**Report: Deficiency Report
Function: Test, Adjust, & Balance
Date: 10/08/2025
Completed By: National TAB**

**PROJECT
10-06-25 QT #1121 EASLEY, SC**

**QUIKTRIP
4705 SOUTH 129TH EAST AVENUE
TULSA, OK 74134**

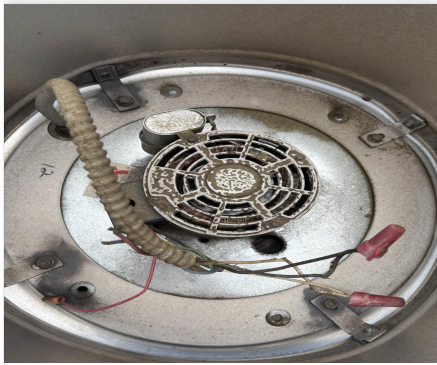
Issue Name : EF-1 not working
Description : When attempting to turn on the fan the motor began to smoke.
Created By : National TAB **Assigned To :** National TAB - Brianna Biggs
Status : Open
Priority : High **Asset Tag :** EF1
Originated Date : 10/08/2025 - Christian Moller - National TAB

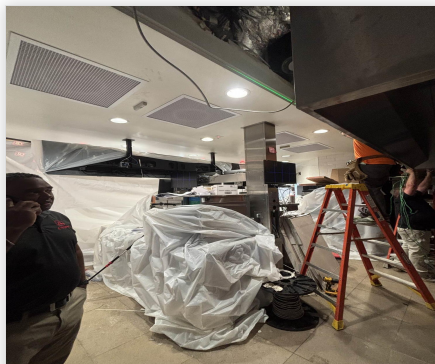
Issue Name : RTU 2 & 3 economizers don't work
Description : RTU 2&3 economizers do not work. When using the dial on the economizer itself as well as the Emerson board the flaps do not open.
Created By : National TAB **Assigned To :** National TAB - Brianna Biggs
Status : Open
Priority : High **Asset Tag :**
Originated Date : 10/08/2025 - Christian Moller - National TAB
